TRANSPORT TECHNICAL NOTE

To: **West Sussex County Council / National Highways**
From: **Iceni Projects Ltd**
Date: **April 2026**
Title: **Reeds Lane, Sayers Common**

1. Iceni Projects Ltd (IPL) has been instructed by Reside Developments to provide transportation advice regarding their development proposals at Reeds Lane, Sayers Common (the Site). A planning application was submitted to West Sussex County Council (WSCC) in December 2025 (ref: **DM/25/3067**) for the following:

National Highways Planning Response (NHPR 25-01) Formal Recommendation to an Application for Planning Permission

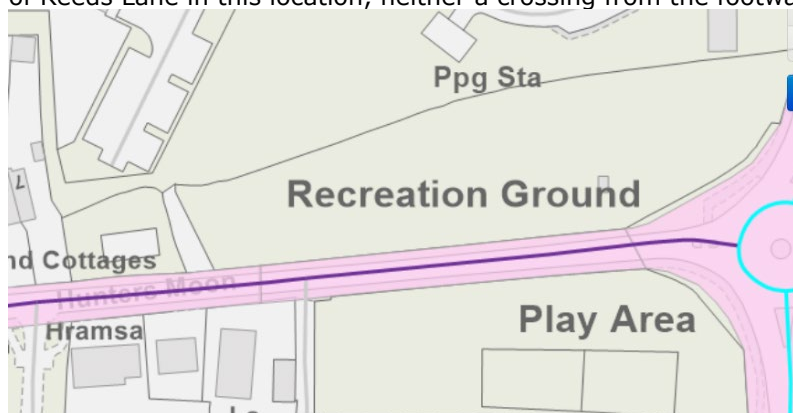
Tactile paving could be provided on the footway at the northern access (Roundhay). Kerbs will require adjustment to accommodate the tactile paving and the footway may require reconstruction.

For the southern access the footway running across the driveway requires reconstruction and levels adjusted to make even. Kerbs could be provided across the footway (dropped to accommodate tactile paving).

The applicant should provide a drawing detailing these works within the public highway. These works would be secured as part of off-site highway works under s278 agreement.

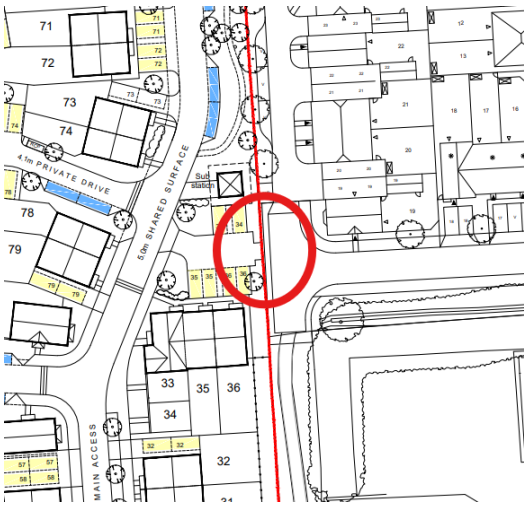
The extension of the 30mph would only be appropriate if the clear visibility distance (CVD) of the terminal signs is able to be adhered to. Based on the 85th percentile speeds, for a 60mph road meeting a proposed 30mph, the CVD would need to be 40m. If the 30mph is deemed the appropriate solution, we would also recommend that the gateway features should be brought forward to match the terminal locations and a suitable amount of vegetation clearance would be required to meet the CVD.

Alternatively a suitable length of 40mph buffer would also be supported, this would provide a consistent user experience, and be aligned with the mean speeds required for a 40mph. The CVD required for 40mph terminals would be 95m.

The applicant should consider the above and clarify whether Road Safety group requirements can be met, in order for the auditor recommendation to be incorporated. The LHA consider that using MfS2 to calculate stopping sight distance is acceptable on basis of built-up area changing and with the 30mph/village gateway potentially being extended to cover the site/ 40mph buffer depending on what the applicant is able to demonstrate.

13. As visibility splays are achievable in both directions in accordance with the recorded speeds, as such it is not deemed necessary to relocate the speed limit change terminal. However, should the LHA wish to relocate the speed limit terminal then the applicant would be happy to pay for the Traffic Regulation Order. The timing of this may be better in relation to the future development of the site to the immediate south.

Client's Name: Reside
Job Title: Land at Reeds Lane, Sayers Common
Drawing Title: Site Layout
Scale: 1:500 @ A1 / 1:1000 @ A3
metres 10 20 30 40 50
Drawn: KE, Checked: AK, Date: 23.10.25
Job No: 7463, Drawing No: PL-02, Rev: G
Status: APPROVAL

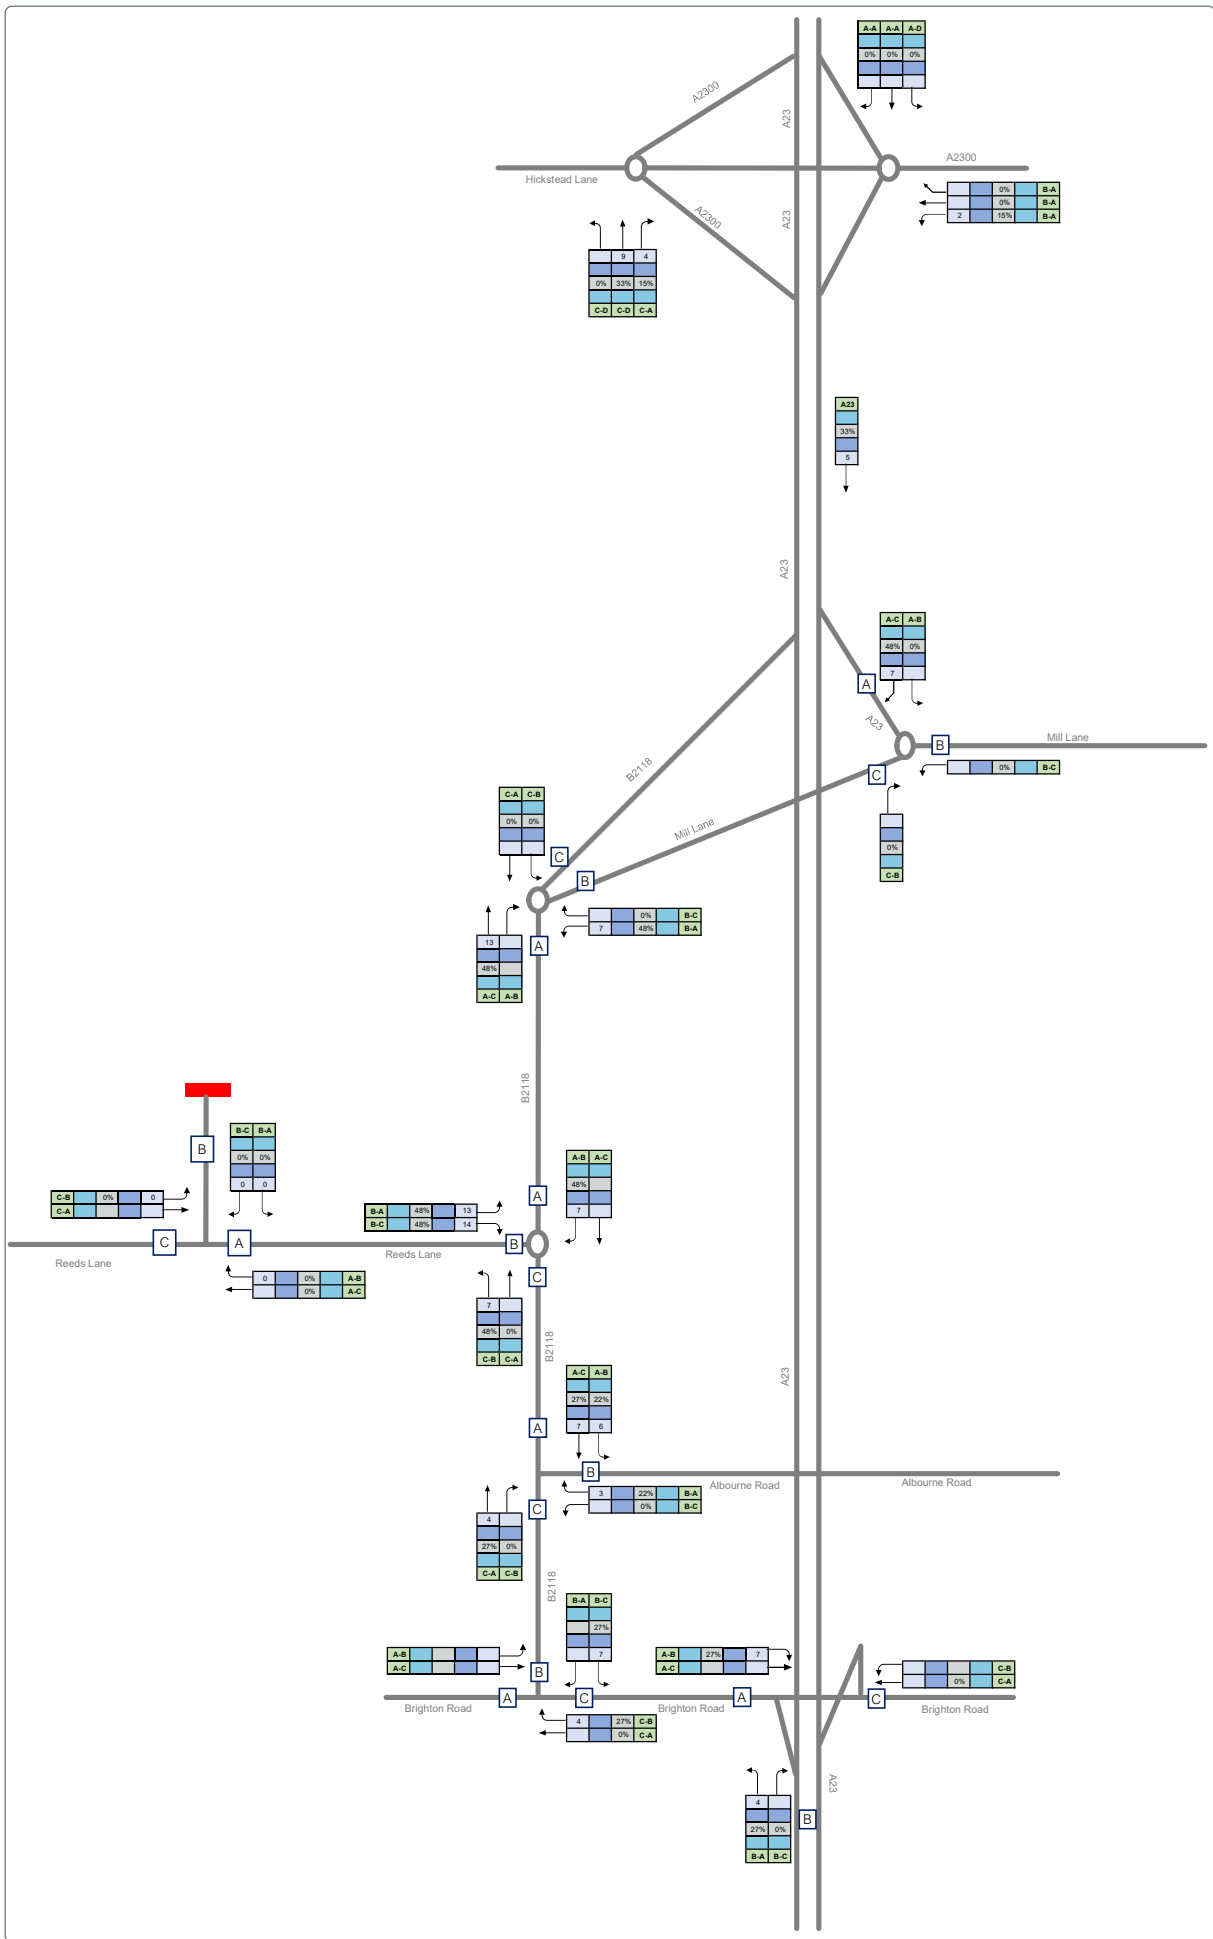
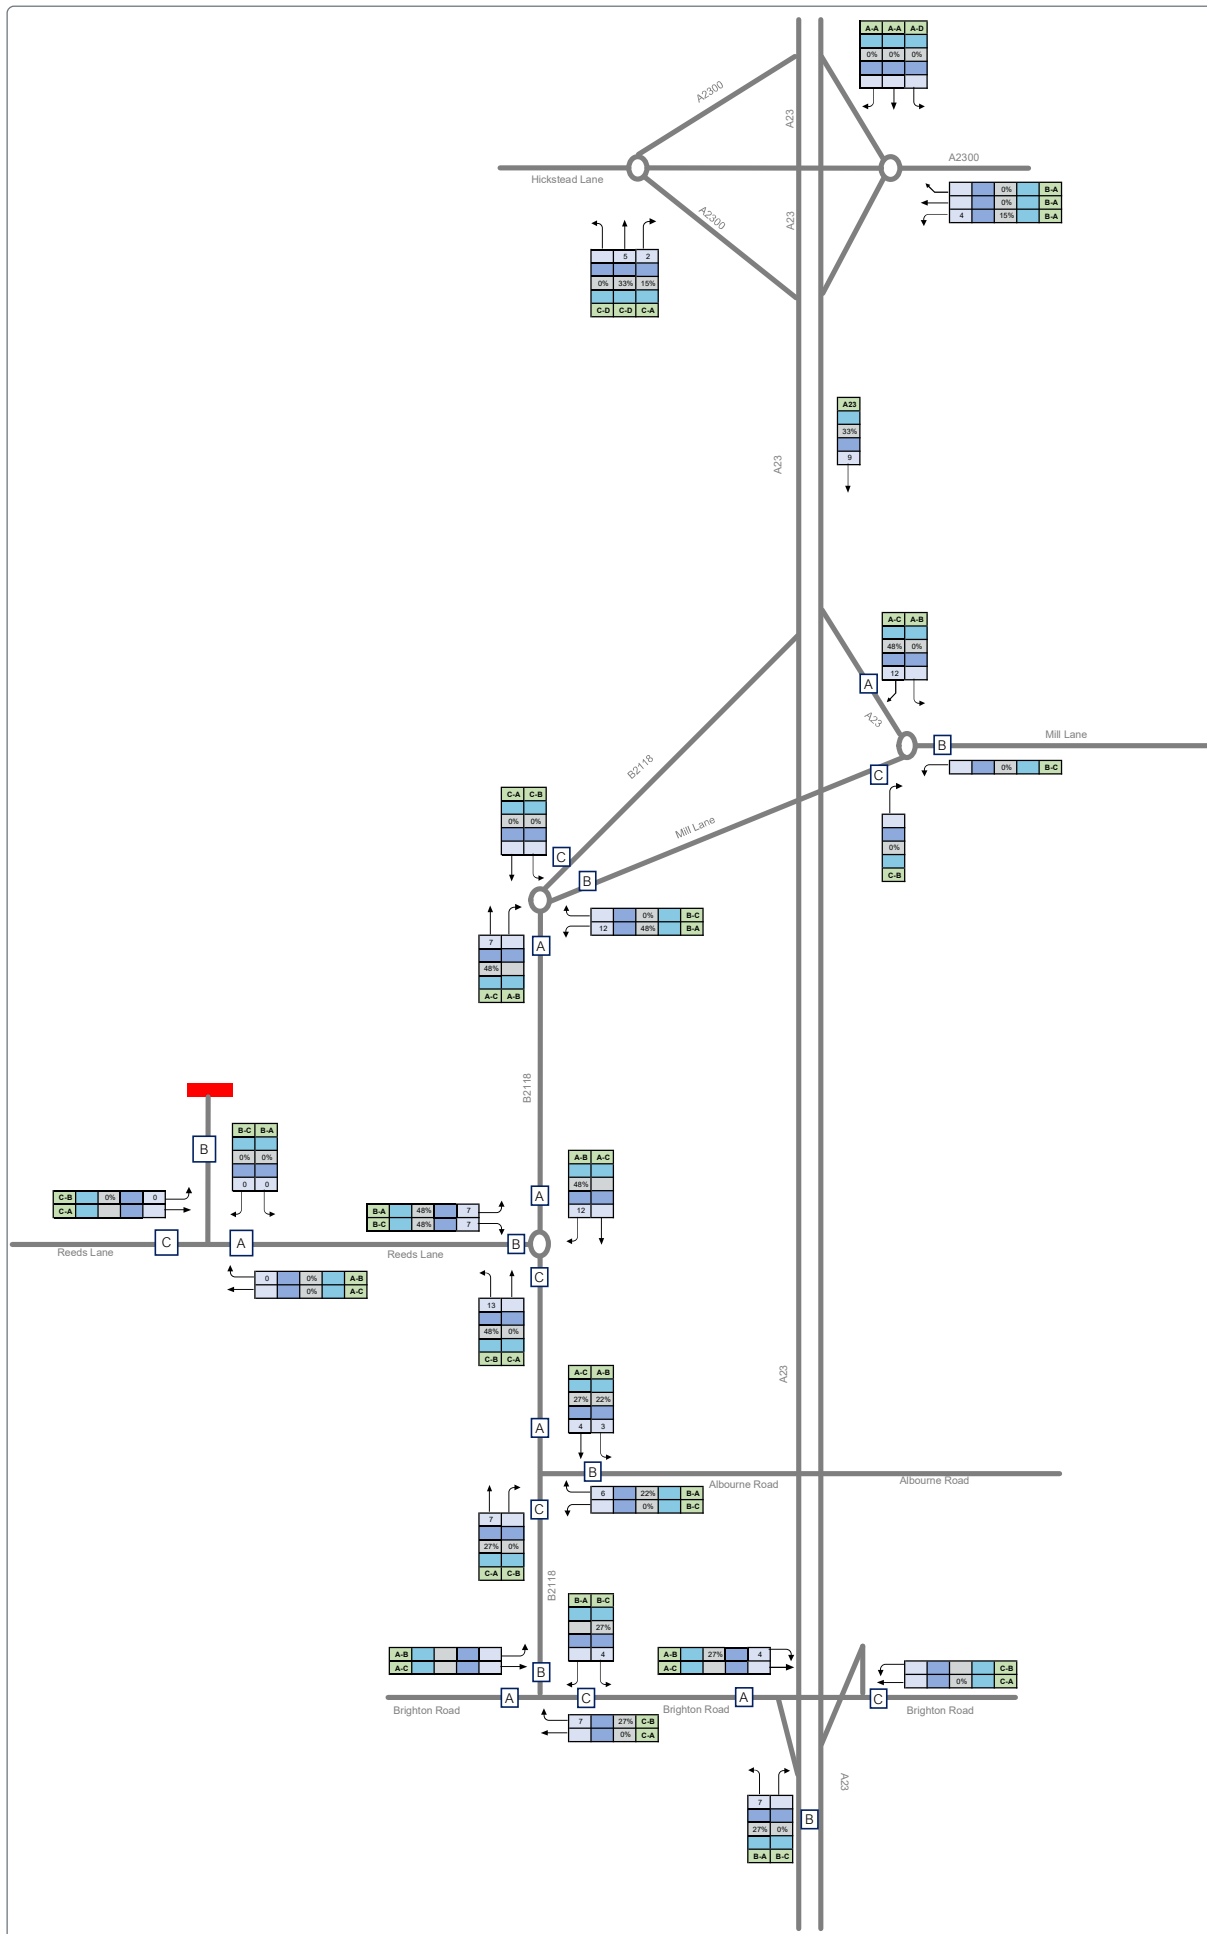
Car parking - additional access aisle hatching/lining and signing to make some visitor spaces suitable for disabled/accessible use.

Detailed drawing of link proposed from parking court north of plot 36 to turning head in adjacent site DM/22/0640.

Detailed drawing of path shown in northeast corner adjoining adjacent site DM/22/0640.

14. Amendments have been made to the Site Layout Plan provided at **Appendix A2** so that 8 parking bays can accommodate additional access aisle hatching and signing to make them suitable for disabled/accessible use. The dimensions of the amended parking bays are 3m x 6.6m.

28. The updated Site Layout Plan provided at **Appendix A2** demonstrates the link proposed from the parking court north of plot 36 to the turning head in the adjacent site DM/22/0640.

29. The updated Site Layout Plan provided at **Appendix A2** demonstrates the path shown in the northeast corner adjoining adjacent site DM/22/0640.

PROPOSED ACCESS WITH VISIBILITY SPLAY

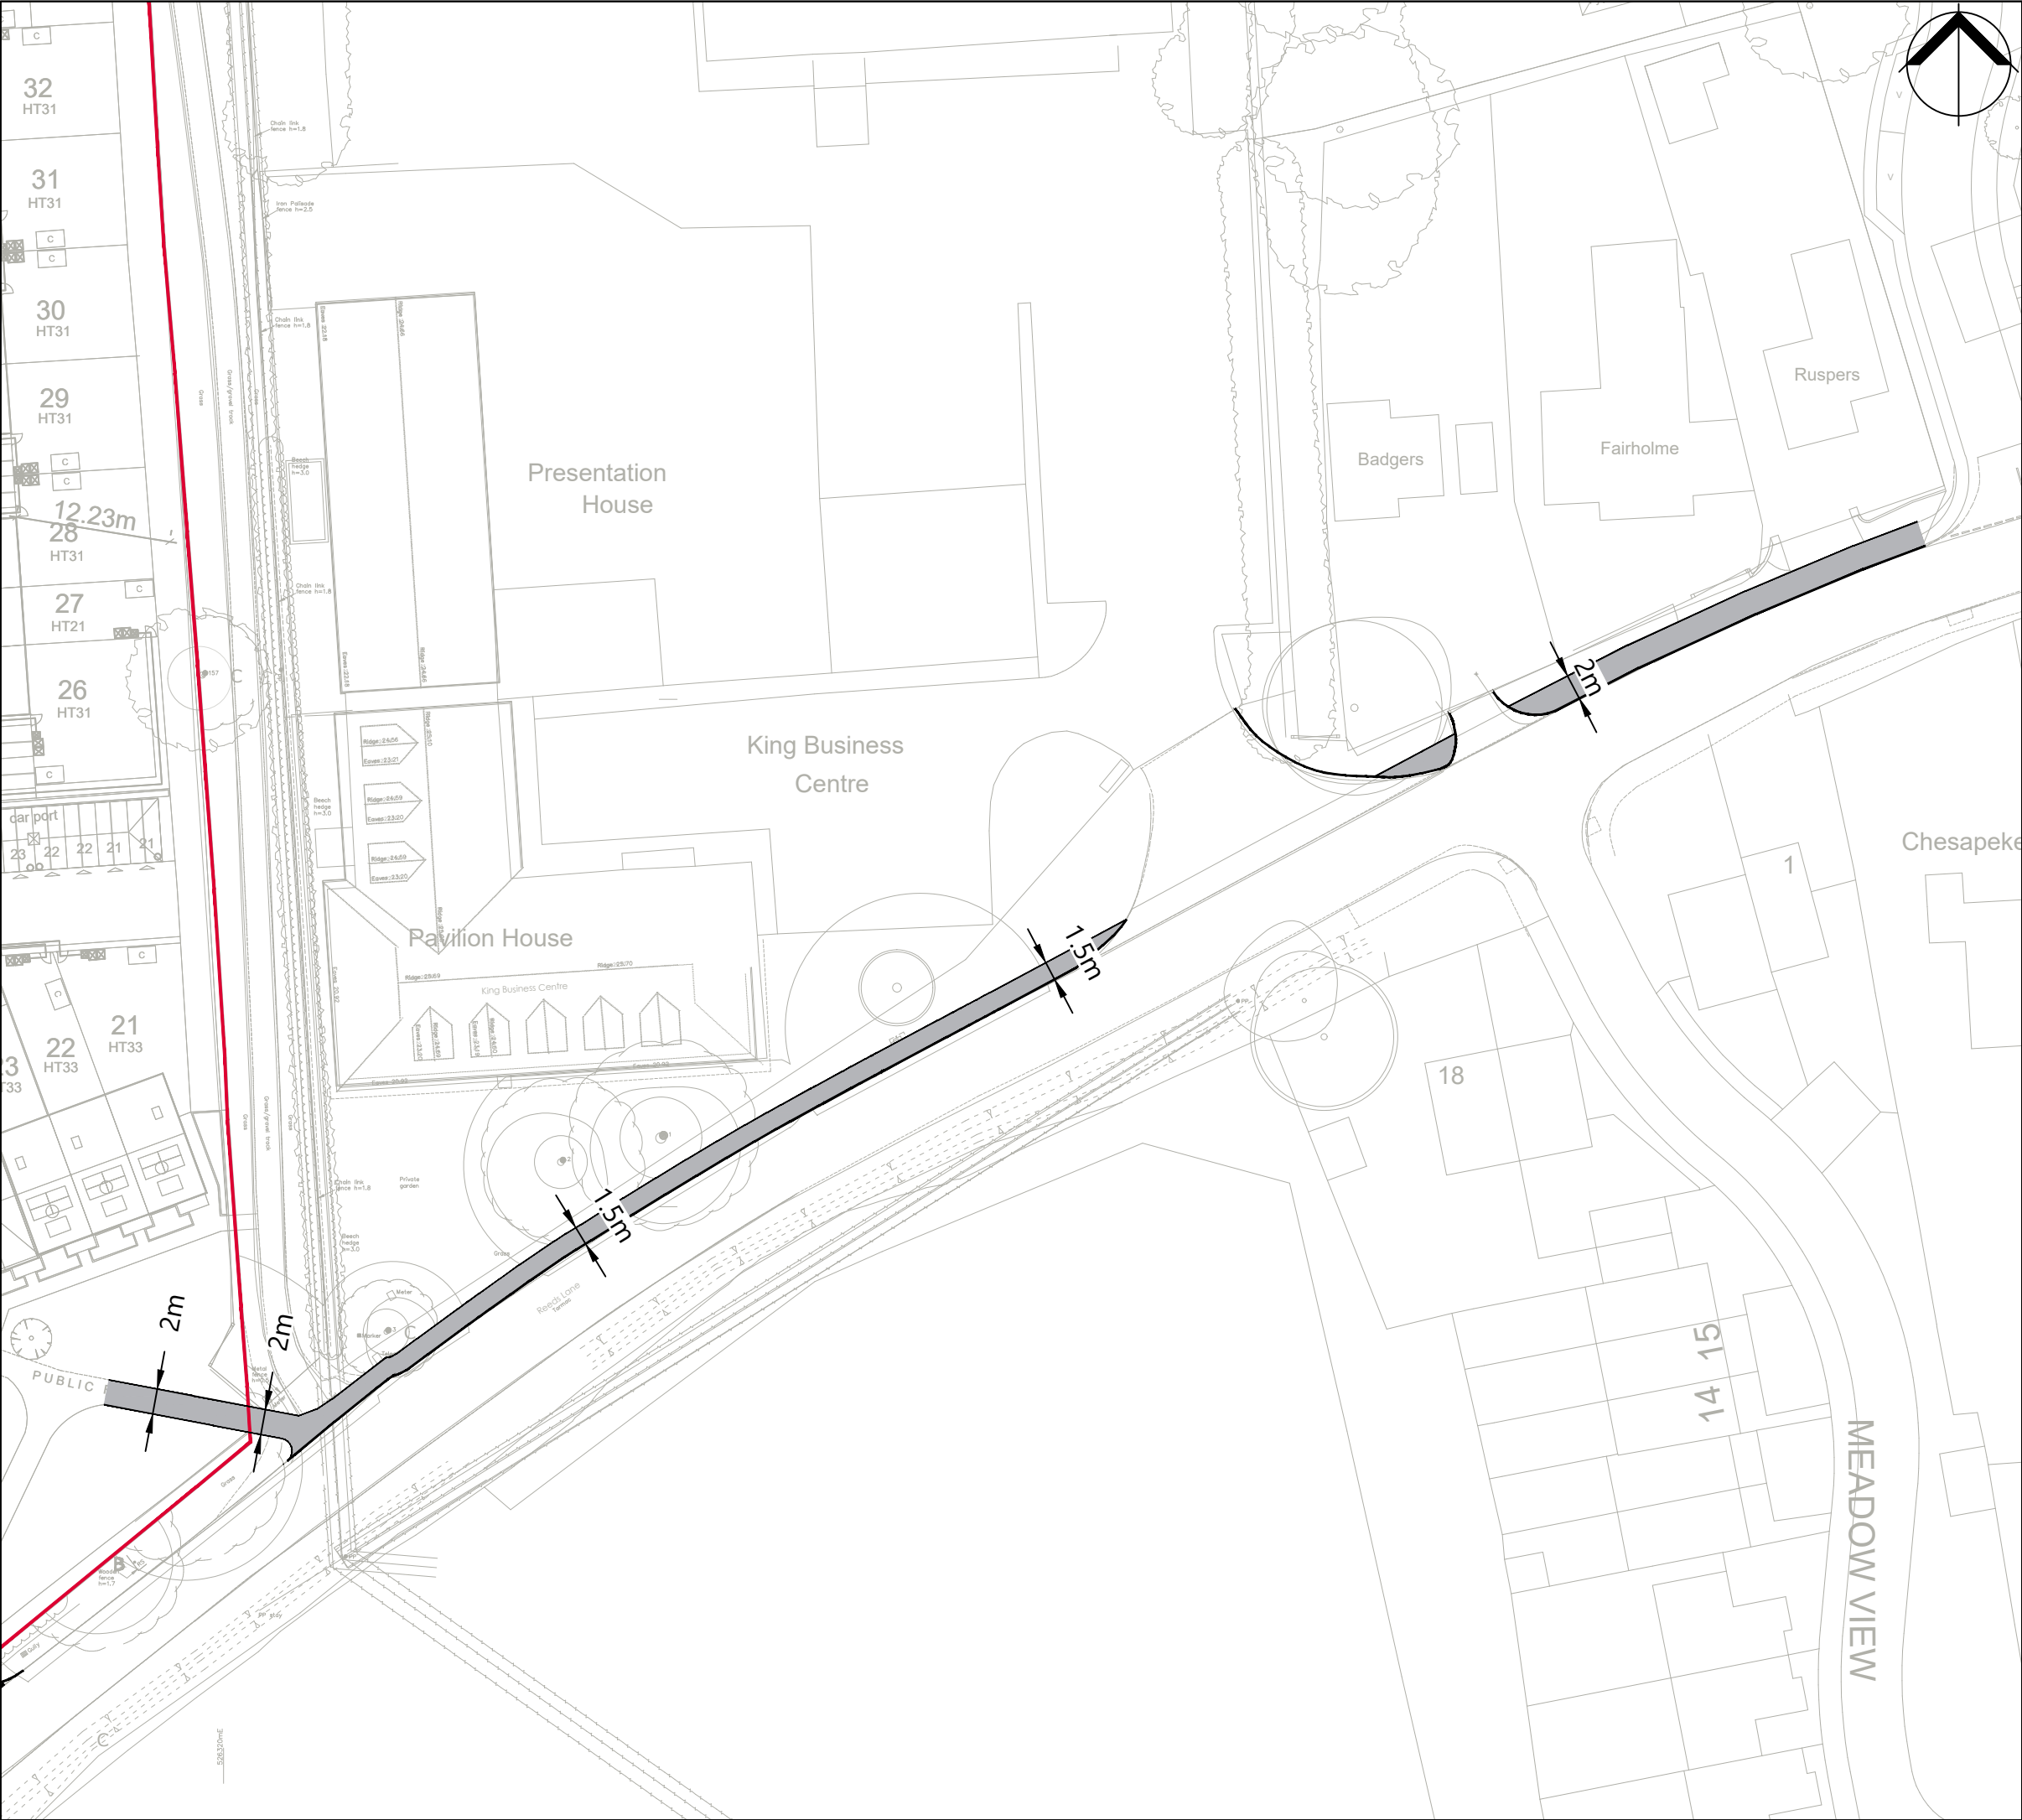
require splays of 92m southwest splay and 98m northeast splay. There does appear to be additional splay achievable, and applicant could demonstrate this.

30. **Drawing I002003_04** is provided at **Appendix A4** showing the visibility splays.
